ADDENDUM NO. 1
SOLICITATION NO.: FDVA-ITB-26-0010B
SOLICITATION TITLE: CHESTER SIMS NURSE CALL SYSTEM

ISSUE DATE: JUNE 10, 2026

CABLE PATHWAYS: EXISTING CONDUITS AND RACEWAYS MAY BE REUSED WHERE ADEQUATE AND IN GOOD CONDITION. VERIFY ALL PATHWAYS PRIOR TO INSTALLATION. DAMAGED OR UNDERSIZED PATHWAYS SHALL BE REPLACED.

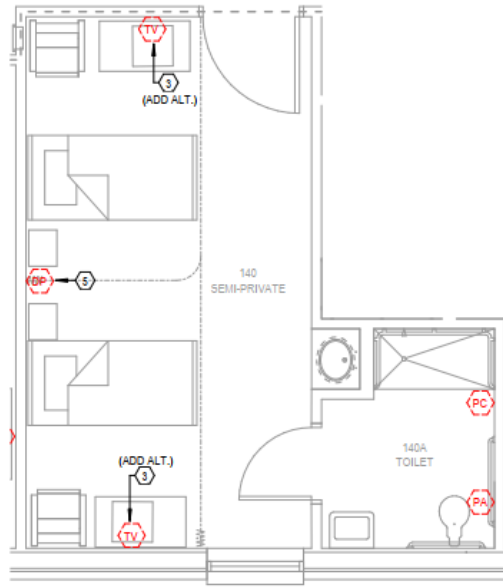
Do the PC in bathrooms need new raceways or is there existing conduit?

Refer to “Cable Pathways Note” on sheet NC000, which has been clipped below for reference.

If the presence of suitable existing pathways in the patient restrooms was not verified during the mandatory on-site meeting, contractors may include the following qualification in their bid:

“This bid assumes that existing raceways are installed from wall backboxes to an accessible ceiling space (i.e., above accessible ceiling or within accessible utility areas without removal of hard ceilings) to serve nurse call devices within the patient restrooms.

In the event it is discovered that the necessary raceway is either not present or not suitable for re-use (i.e., not continuous, not code-compliant, improperly sized, or not aligned with device locations), additional cost will be incurred for material and labor necessary to install new raceway.

This bid includes a unit price of \$____ per linear foot for installation of concealed raceway. Linear footage shall be measured along the actual installed pathway from the device backbox to the accessible ceiling space.

Unit pricing shall apply only where suitable existing raceway is not present for devices included in this project scope and shall include all material and labor required for installation, including patching and repair of walls and ceilings to match existing conditions.”

2 TYPICAL 2 BEDROOM DEMOLITION PLAN
1/4" = 1'-0"

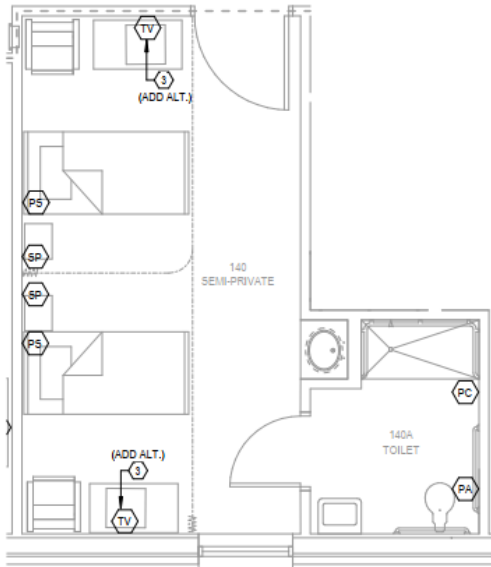
Do we need to provide raceway for this alternate and the additional devices behind the beds?

The owner is no longer pursuing the add alternate referenced on sheet NC401 for Pillow Speaker/Television integration. Perspective bidders are not required to provide breakout pricing for this alternate and the alternate will not be included in the scope of the project. For semi-private patient rooms, dual-patient call stations can be utilized rather than installing (2) individual single patient call stations. Refer to updated NC401 plan issued along with this response letter.
